ZONING AMENDMENT,
PLANNED UNIT DEVELOPMENT &
SUBDIVISION STAFF REPORT

DEVELOPMENT NAME Cornell Subdivision

LOCATION 1757 Old Shell Road (Rezoning site)
(South side of Old Shell Road, 150'± West of Semmes Avenue)

SITE PLAN

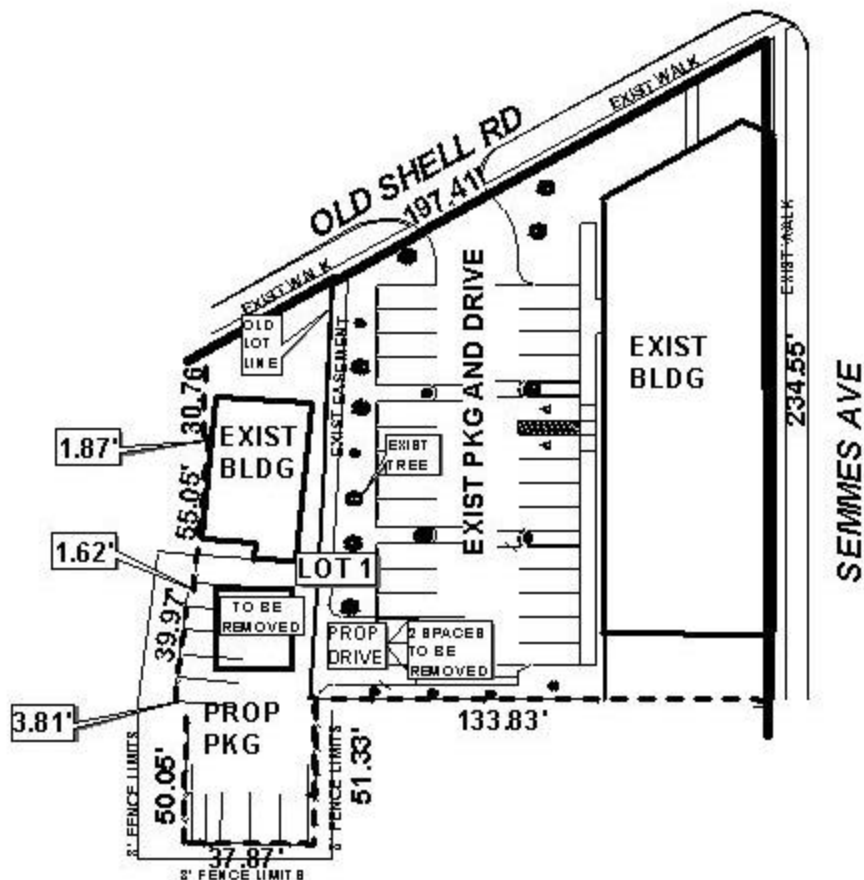
ENGINEERING COMMENTS We need a 25' radius at the intersection of Old Shell Road and Semmes Avenue. If a 25' radius is not available due to the location of the building, we recommend the maximum radius possible without interfering with the building structure. This is a heavily traveled intersection with an elementary school directly across the street. Must comply with all stormwater and flood control ordinances. Any work performed in the right of way will require a right of way permit.

Additionally, it appears that the existing parking lot complies with the landscaping and tree planting requirements of the Ordinance; however, the lot onto which the parking is being expanded, should comply with the landscaping and tree planting requirements as well. Another point to consider is that although the site adjacent to the West is zoned commercially, it is used residentially, thus the provision of a buffer, in compliance with Section IV. D.1. should be required along both the West and South property lines. Furthermore, if there is no sidewalk in front of the existing residence, one should be provided.

As stated above, the subdivision request is to simply consolidate four lots into one lot. There is no existing radius at the intersection of Semmes Avenue and Old Shell Road and as outlined in the City Engineering comments, a 25' radius is needed. However, if a 25'

radius is not possible due to the location of the building, the maximum radius possible without interfering with the building structure should be required. Additionally, the site should be limited to the one existing curb cut to Old Shell Road.

Subdivision: With modifications, the plat will meet the minimum requirements of the Subdivision Regulations and is recommended for Tentative Approval subject to the following condition: 1) dedication of a 25-foot radius or the maximum radius possible without interfering with the building structure.
